DART SERVICE INSTRUCTION

TO AMEND IIN-D412-704 REV. C OR EARLIER

AND ICA-D412-704 REV. 4 OR EARLIER

The purpose of this Dart Service Instruction is to correct part number error in Installations Instruction IIN-D412-704 Rev. C or earlier and Instructions for Continued Airworthiness ICA-D412-704 Rev. 4 or earlier. The AN3-13A bolt should be replaced with an AN3-10A bolt in Figure 5 - Detail L in IIN-D412-704 and Figure 25-4 Detail L in ICA-D412-704. See sheet 2.

Figure 5 - Detail L or Figure 25-4 - Detail L

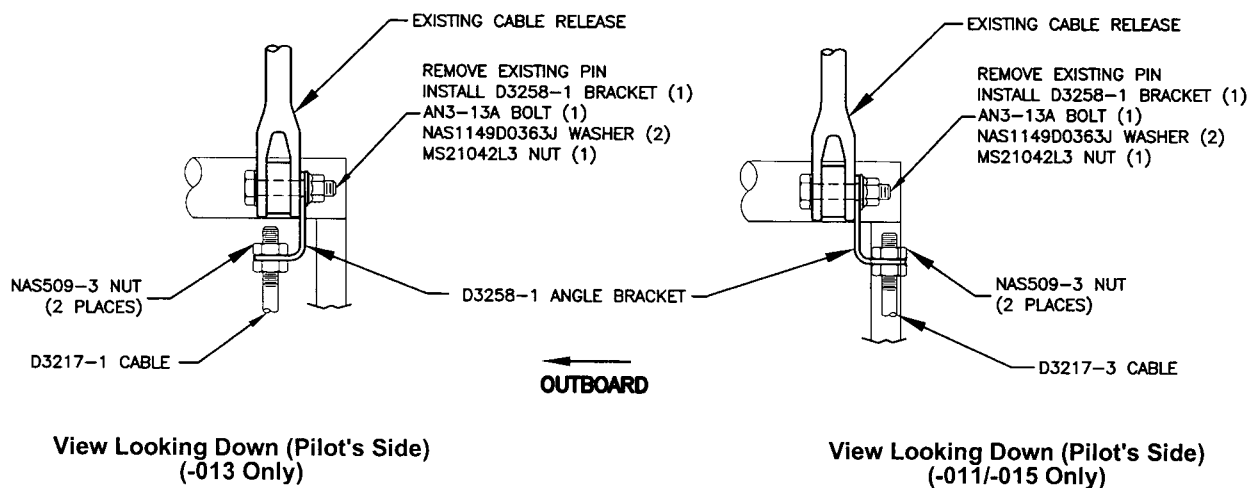
Revise Detail L Figure 5 of IIN-D412-704 and Detail L Figure 25-4 of ICA-D412-704 as follows:

NOW

WAS
